Declaration in regard to the SpaceX Starlink™ network

Purpose: The purpose of this declaration is to point out deficiencies in the Radiation Hazard Report filed by Space X in support of the FCC's Radio Station Authorization and support an Environmental Assessment of the whole satellite/ground station program.

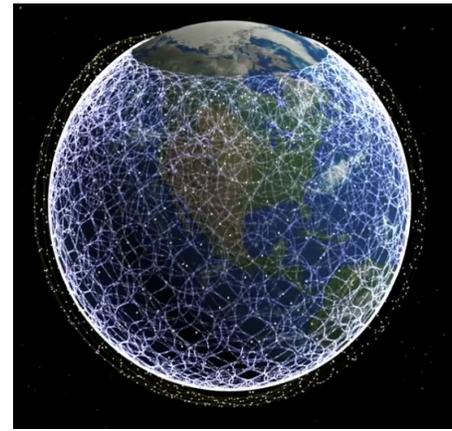
As stated in the Application for Expedited Review, notwithstanding that earth stations and satellites form one wireless infrastructure, the FCC and applicant companies like SpaceX are approaching the program in a piecemeal fashion, seeking approval in each case without any regard to the whole. But as Professor Heroux mentions, the whole planet will be irradiated by thousands of SpaceX and other satellites, each beaming down RFR to many CP terminals and larger base stations in a many-to-many relationship, blanketing the Earth, and every living being on it with RFR. The consequences of this are totally unknown, and have never been modeled publicly, let alone studied. The above image depicts what this RFR blanket may look like.
